Edition 3/2008

New BPW shock absorbers

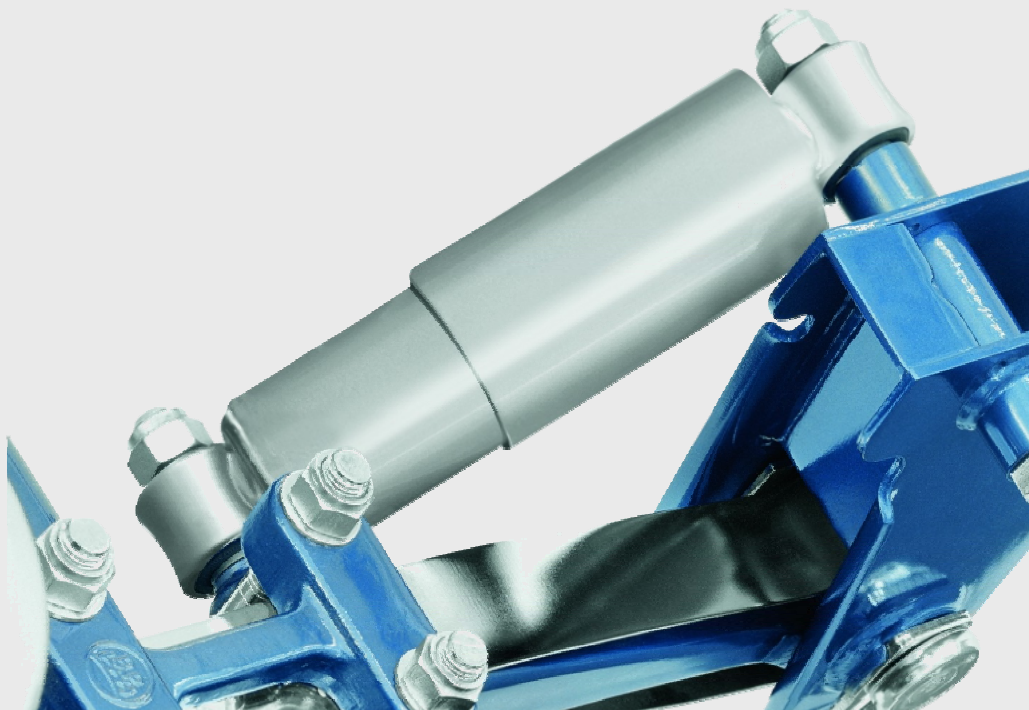
The further technical development of tried-and-tested BPW shock absorbers has delivered additional benefits:

- Very good damping properties because of optimised characteristics and improved response
- Optimised installation space because of a protective tube with a reduced diameter from 82mm to 75mm (lower tube 72 mm to 65 mm)
 - Weight reduction by about 1 kg (per axle)
- Identical installation and connection dimensions compared to previous version guarantee 100% exchangeability

- Note that the units on each axle must be replaced as a set
(2 identical dampers per axle)
- However, it is permitted to have different units on individual axles
within the vehicle.
- The familiar "old" variants will be phased out and all will be replaced
by the new variants
- This means there will be fewer variants, easier warehouse logistics
and identification
